1991 - 1992 Corvette: Service Bulletin: Starter Inoperative/Clicks/No Start

Subject: Starter Inoperative/Clicks/No Start

Model and Year: 1991-92 Corvette with Automatic Transmission

Bulletin Number: 92-322-6D

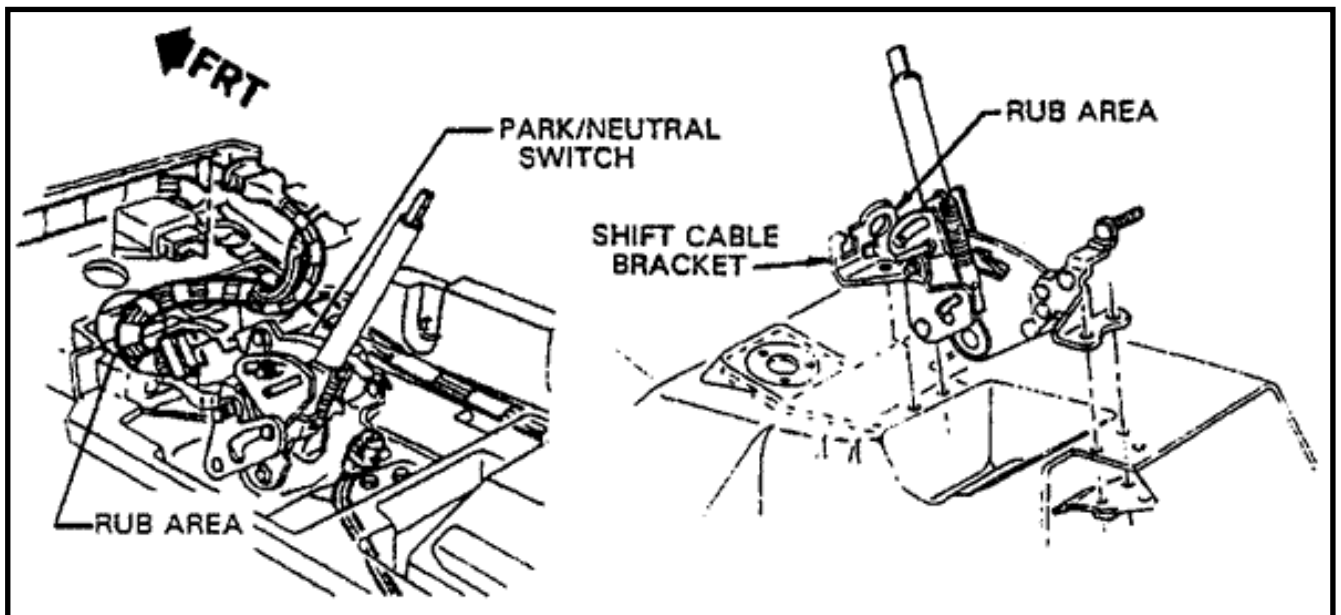
The 10 gauge purple wire from the park/neutral switch in the console is rubbing against the shift bracket (see illustration). This causes high resistance in the circuit, resulting in low voltage to the starter.

1. Disconnect negative battery cable.
2. Remove console trim plate as shown in the 1992 Y Car Service Manual, page 8C-11.
3. Check the wire harness in the area shown in the illustration for signs of rubbing. Correct as necessary.

4. Reroute the harness to the right of the bracket, about 50 mm (2 inches) over, and under the plastic portion of the console. Secure as needed to insure that the harness cannot contact the bracket
